Item ID: D206-642-341BL Accept ***N900040100*** Setup Start ***NS1***
Revision ID: Stop ***NS2***
Item Name: Replacement Skidtube (Fits LH or RH)
Start Date: 8/4/2017 Start Qty: 1.00 ***1*** Cust Item ID:
Required Date: 9/25/2017 Req'd Qty: 1.00 ***1*** Customer:
Reference:

DRAWING NO. D2650	TITLE 206/407 SKIDTUBE ASSEMBLIES	REV. F	DART AEROSPACE LTD ENGINEERING ORDER		D.E.O. NO. D2650-F-1	SHEET NO. SHEET 1 OF 1	SCALE NTS
DRAWN <i>[Signature]</i>	CHECKED A.P.	MFG. APPR. <i>[Signature]</i>	APPROVED <i>[Signature]</i>		DE APPR. <i>[Signature]</i>		
DATE 12.10.12	DATE 12.10.22	DATE 12.10.22	DATE 12.10.22		DATE 12.10.22

CHANGE C'BORED WELDED CROSSBOLT SPACERS TO SWAGED SPACERS

AMENDMENT TO DETAIL B
NOT TO SCALE

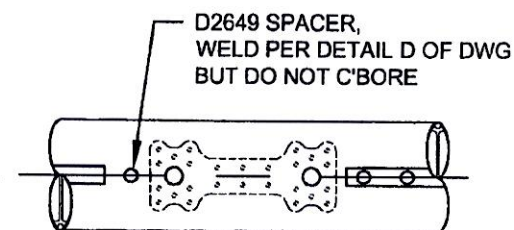
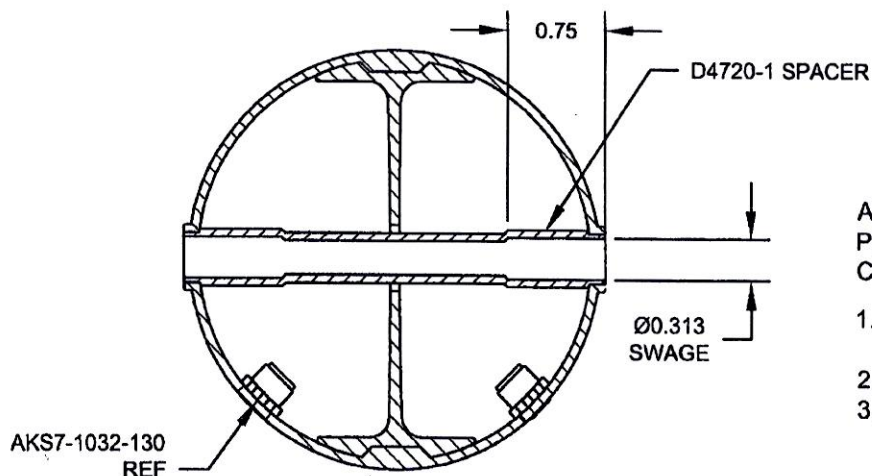
PARTS LIST IS AMENDED AS FOLLOWS:

IS:

QTY	QTY	QTY	QTY	PART NUMBER	DESCRIPTION
-1	-3	-5	-7		
1	1	0	0	D2649	CROSS BOLT SPACER
16	17	19	23	D4720-1	SPACER

WAS:

17	18	19	23	D2649	CROSS BOLT SPACER
----	----	----	----	-------	-------------------

ADD DETAIL G BELOW, WHICH IS THE SAME SECTION VIEW AS DETAIL D OF DWG.

C'BORED HOLES ARE NOW SWAGED PER DETAIL G BELOW. FOR THE Ø0.375 HOLE THAT IS NOT C'BORED, WELD PER DETAIL D OF DWG (SEE AMENDED DETAIL B FOR REFERENCE).

DETAIL G

FOR Ø0.375 HOLES ONLY
FOR HOLES THAT ARE CURRENTLY C'BORED ONLY
NOT TO SCALE

AFTER DRILLING AND BENDING ASSEMBLY
PERFORM THE FOLLOWING FOR Ø0.375 HOLES THAT ARE
CURRENTLY C'BORED:

1. INSERT D4720-1 SPACER, 16 PL (-1) OR 17 PL (-3)
OR 19 PL (-5) OR 23 PL (-7)
2. SWAGE TO Ø0.313 X 0.75 DP PER QSI 002
3. TRIM / GRIND FLUSH PER QSI 002
